# **USE ON REVIEW REPORT**

►	FILE #: 3-C-21-UR		AGENDA ITEM #: 2
			AGENDA DATE: 3/11/202
►	APPLICANT:	875 CORNERSTO	ONE MULTIFAMILY DEVELOPMENT
	OWNER(S):	USCC Real Estate	e Corp.
	TAX ID NUMBER:	131 069 (PART (	OF) View map on KGI
	JURISDICTION:	County Commissi	on District 6
	STREET ADDRESS:	875 Cornerstone I	Dr.
►	LOCATION:	East side of Corr Lovell Rd.	nerstone Dr., north side of Murdock Dr., southeast of
۲	APPX. SIZE OF TRACT:	12.35 acres	
	SECTOR PLAN:	Northwest County	
	GROWTH POLICY PLAN:	Planned Growth A	rea
	ACCESSIBILITY:	43.5 feet within a	of Murdock Dr., a minor arterial with a pavement width of right-of-way width of 88 feet, and off of Cornerstone Dr., a pavement width of 39.2 feet within a right-of-way width of
	UTILITIES:	Water Source:	First Knox Utility District
		Sewer Source:	First Knox Utility District
	WATERSHED:	Turkey Creek	
►	ZONING:	OB (Office, Medi	cal, and Related Services) / TO (Technology Overlay)
۲	EXISTING LAND USE:	PP (Public Parks	)

## 875 CORNERSTONE DRIVE APARTMENTS KNOX COUNTY, TENNESSEE

Subject: TIS Comment Response Document for 875 Cornerstone Drive Apartments Review Comments Dated: February 18, 2021 (Knoxville-Knox County Planning)

FIGURE 4 2020 EXISTING RAW TRAFFIC VOLUMES

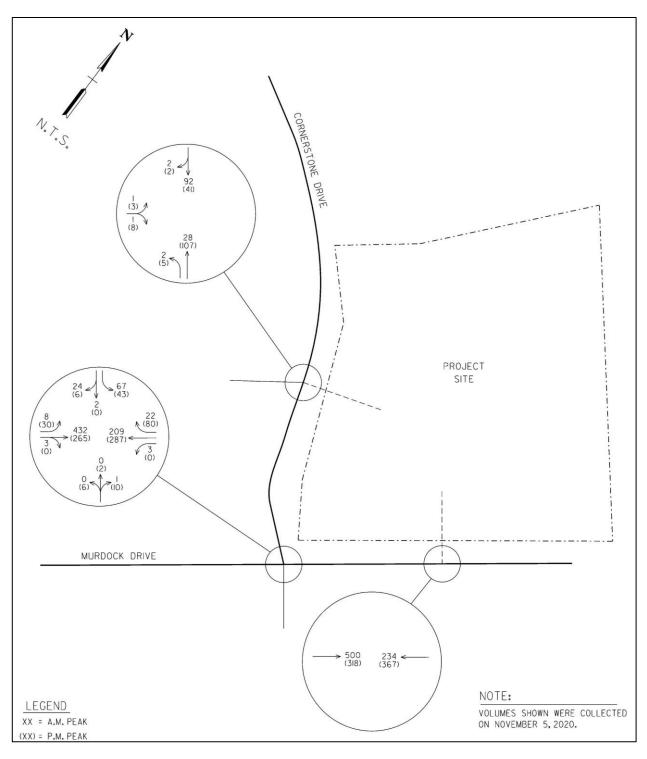
3. <u>Reviewer Comment</u>: On page 6, with both traffic counts being completed at the same time, there is some discrepancy with the volumes balancing. The volumes between the two count locations are for the same peak hours and they do not have any other intersections between them. Therefore, for example, we would expect the northbound movement from Murdock Drive at Cornerstone Drive to be the same in the AM and PM as the northbound movement at the project driveway on Cornerstone Drive (i.e. the volume coming out of one intersection equals the volume coming into another intersection). This is true for the AM peak, northbound PM peak, and southbound PM peak volumes. The traffic heading north on Cornerstone Drive from Murdock Drive is 312 vehicles, but only 113 northbound vehicles arrive at the US Cellular driveway. Please revise or explain why the difference since there is no place for traffic to go.

<u>Response</u>: This discrepancy is due to a typo for the westbound right turn volume at the intersection of Murdock Drive at Cornerstone Drive when transposing the data collected and shown in Appendix A to FIGURE 4. The westbound right turn volume was depicted as 280 vehicles for the PM peak hour and should have been depicted as 80 vehicles. The peak hour volumes between the intersections of Murdock Drive at Cornerstone Drive and US Cellular Office Access at Cornerstone Drive now balance as expected. Revised FIGURE 4 can be found on page 6.
